<b>T.I. no.: 2017 - 17</b> Updated: -	<b>Topic: Water tank and milk foam system</b>
--	---

<b>Date: 04.09.2017</b>	<b>Priority</b>	<b>Need for action</b>
Affected machines: SCClub	High	As soon as possible
From serial number: -	X Medium	X On next visit to the machine
As of date: -	Low	FYI only

Optimised level sensor

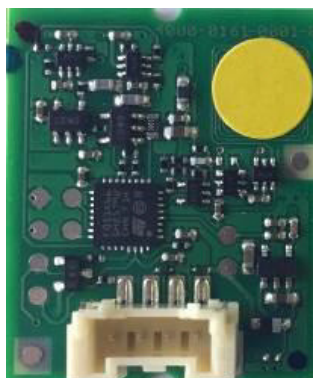
The following messages from the field made it necessary to adapt the empty message sensor technology on the level sensor:

- Water tank is drained empty in tank machines
- Water tank is not automatically filled in mains water supply machines

In both cases, air is pulled into the boiler water system until the F161 or F162 error messages are generated or the "Time out when filling water tank" error message is displayed.

Decisive for this is altered behaviour between the level sensor and the surrounding conditions of the water tank, water tank height and device gap sizes.

The internal software for the optimized level sensor has been adapted to the altered surrounding conditions. In doing so, the empty message threshold was increased so that the display message for filling the water tank appears on-time for tank machines and automatic refilling is triggered on-time for mains water supply machines.

- Stocks have been corrected, only updated level sensors will be delivered for new orders. (Available CW 37))

### NEW VERSION DISTINGUISHING FEATURES

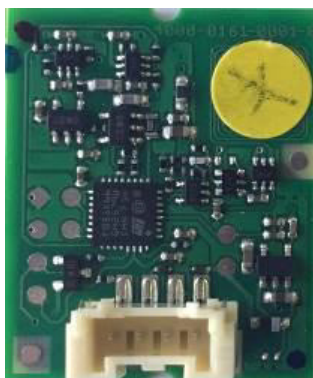
- All level sensors shown here have the same hardware and software version and can be used without limitations.
